UNITED STATES PATENT AND TRADEMARK OFFICE

APPLICATION NO.	FILING DATE	FIRST NAMED INVENTOR	ATTORNEY DOCKET NO.	CONFIRMATION NO.
09/899,464	07/05/2001	Sundaram Ramakesavan	INTL-0596-US (P11737)	3421

DETAILED ACTION

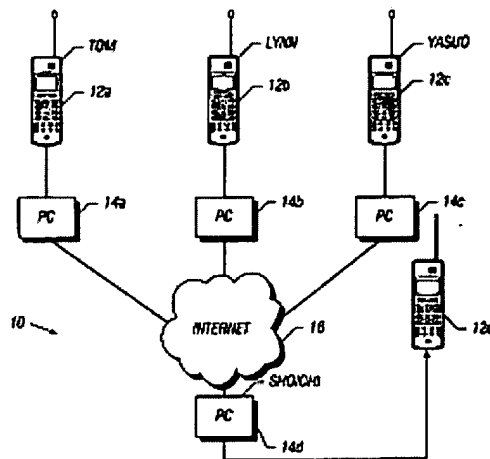
3. New corrected drawings in compliance with 37 CFR 1.121(d) are required in this application because applicant's specification on page 4, lines 1-25, illustrates that **ad hoc network** a plurality of users having a portable computer (14a-d, and the owner's cellular telephone 12---, using wireless protocol including the **Bluetooth protocol** and the **IEEE 802.11 protocol**. Further more, referring to figure 1, the owners of the cellular telephones 12c and 12d are in Japan and their personal computers 14c and 14d utilize the Japanese 20 character set. At the same time, the participants owning the cellular telephones 12a and 12b are in the United States and their owners have personal computers 14a and 14b, which use the English character set. In this example, the personal computers 14a and 14b do not have the script to 25 convert the Japanese characters for display. Applicant is advised to employ the services of a competent patent draftsman outside the Office, as the U.S. Patent and Trademark Office no longer prepares new drawings. The corrected drawings are required in reply to the

Office action to avoid abandonment of the application. The requirement for corrected drawings will not be held in abeyance.

Figure 1, as demonstrated by the figure, one ordinary skill would understand, the cellular telephone 12a-d are couple to portable computer which is connected to the internet infrastructure. And the detailed description also indicates the owners of the cellular telephone 12c and 12d are in Japan and cellular telephone 12a and 12b are in United States. Therefore, the figure does not show how the ad hoc network operates, as ad hoc network is a network with no infrastructure, units communicate and build a network or layers of sub cell to interconnect for communication among each other within radio frequency range. Then how is figure 1, builds an ad hoc network being in Japan and United States. Neither the figure nor detail description is understood to a person

with ordinary skill in the art .
